## LINCOLN CITY/LANCASTER COUNTY PLANNING STAFF REPORT

**P.A.S.:** Change of Zone #3368 **DATE:** June 12, 2002  
Use Permit #144 - Pioneer Woods 1<sup>st</sup> Addition

**PROPOSAL:** Change of Zone: To change the zoning from R-3 to O-3  
Use Permit: To develop 105,000 square feet of office floor area, with requests to allow signs in the front yard, not to show signs on the site plan, to adjust setbacks where lots abut the outlot, to modify the subdivision requirements so that final plats may be based upon the use permit, and to reduce the front yard setback.

# UP 144 Pedestrian Exhibit

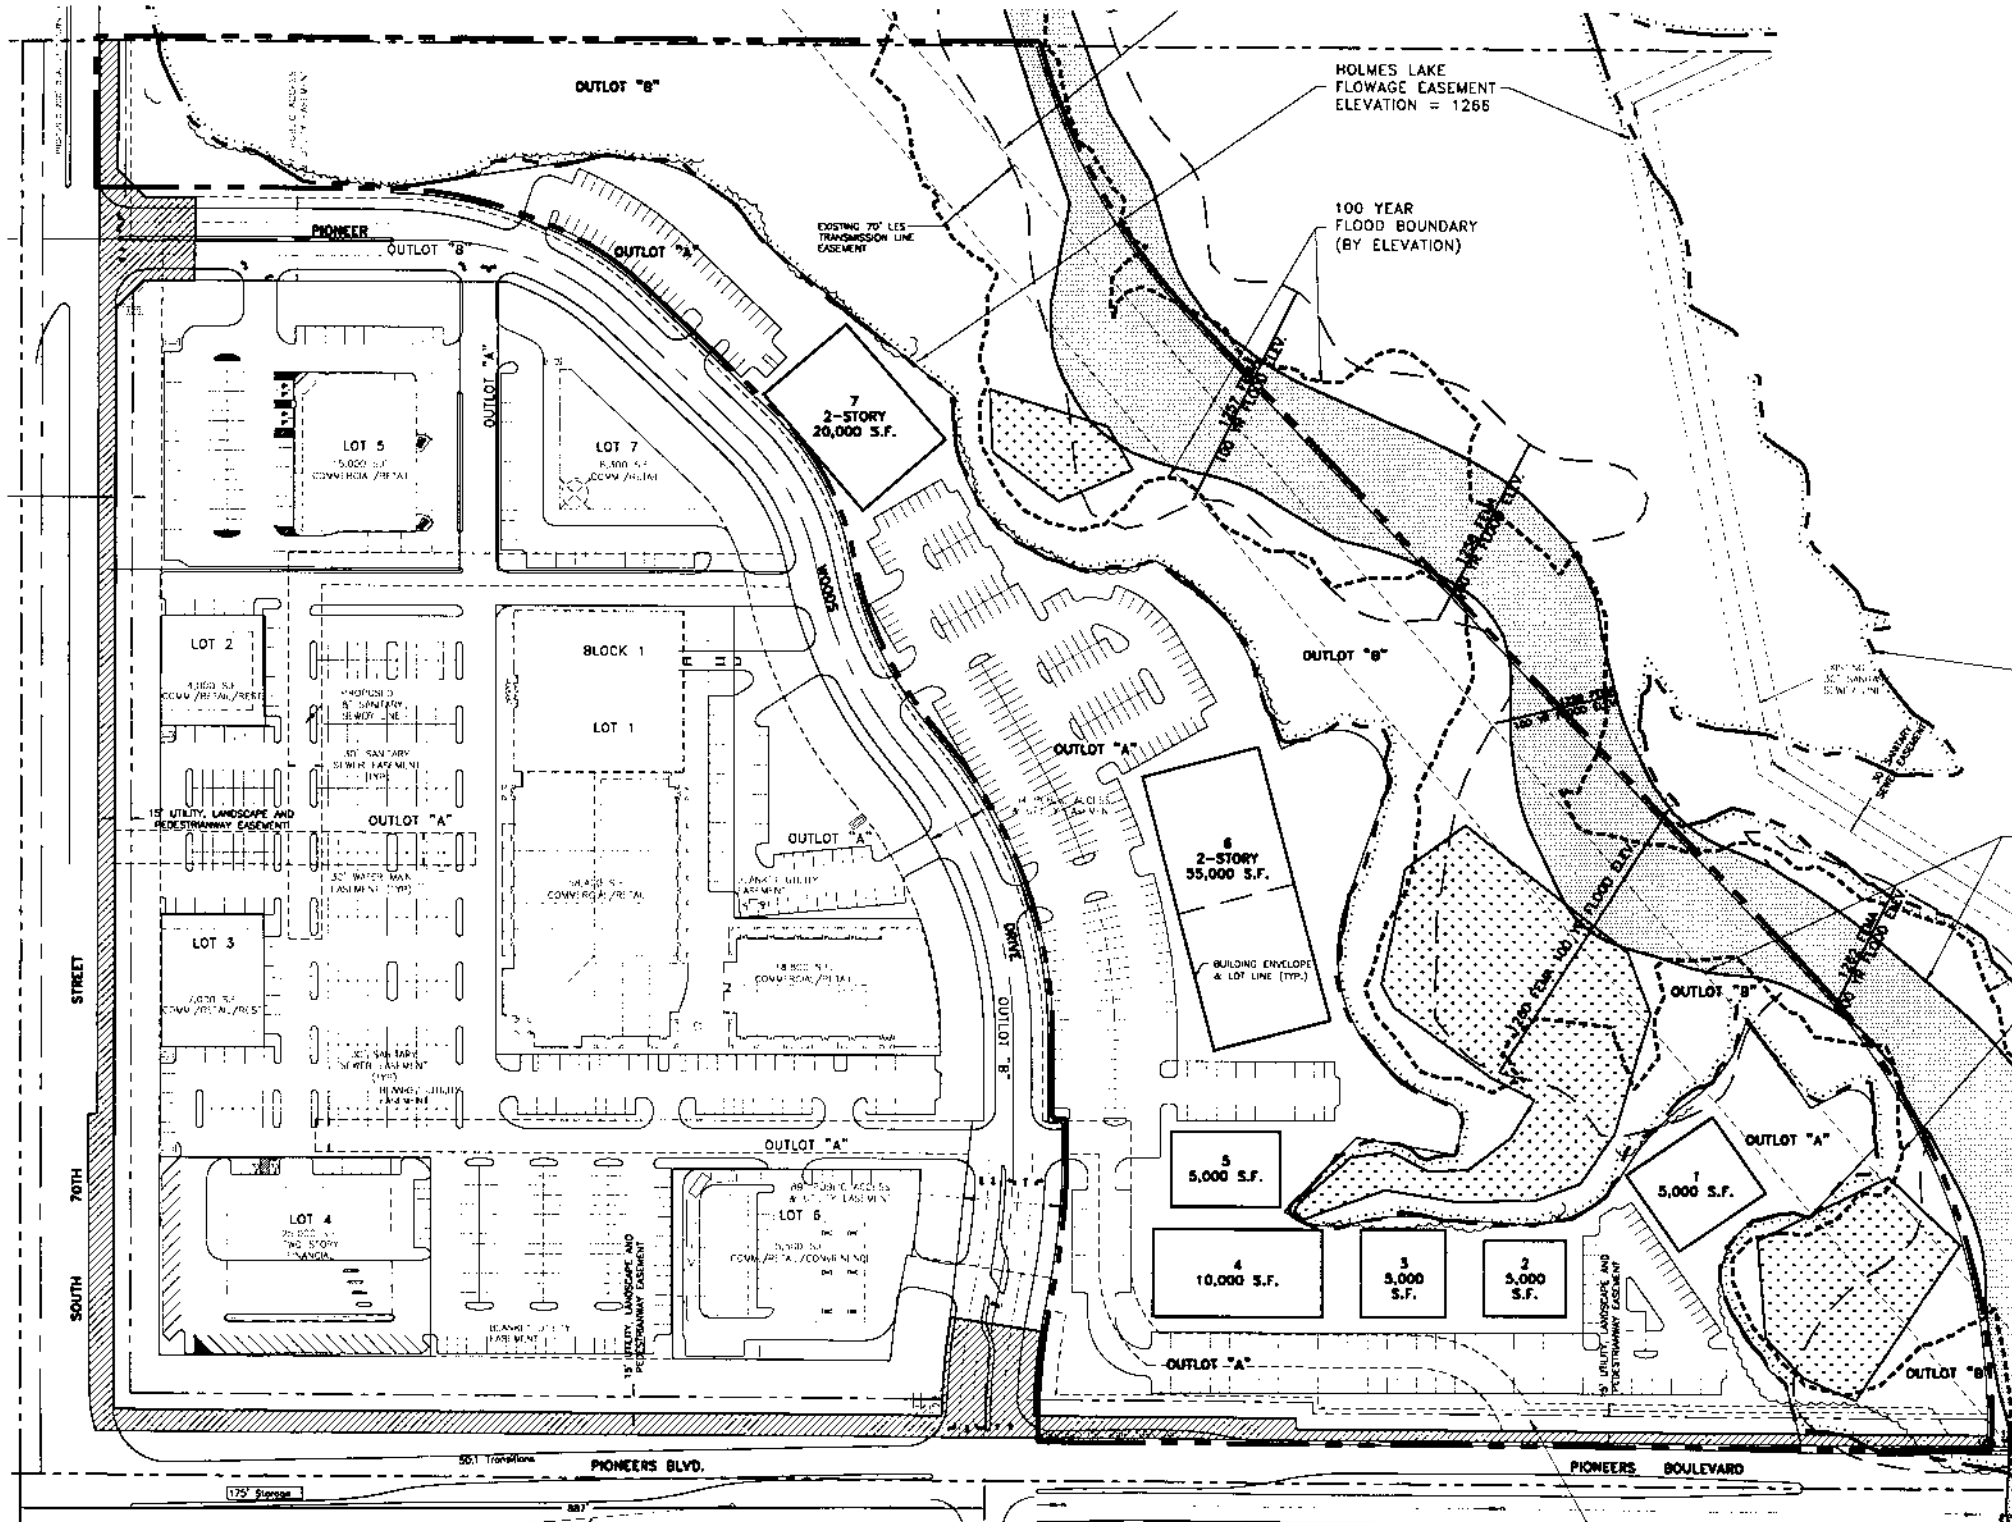
## Distance from Point A to Point B

With connection - 1,700 ft

Without connection - 5,900 ft.

If this development does not provide a pedestrian connection over Antelope Creek, the pedestrian network serving this shopping center is poor.

- 1.1.13 Revise the site and grading plans to show a connection to the future or current bike trail on the east side of Antelope Creek.
  - 1.1.14 Provide designs for the Antelope Creek bicycle/pedestrian crossing which comply with flood plain and other applicable development regulations.

- 3. The owners shall, within the limits of their property, construct a pedestrian connection to the bike trail on the east side of Antelope Creek at such time as the bike trail is constructed, or shall provide a surety in an amount determined by the City to guarantee the construction of the connection.
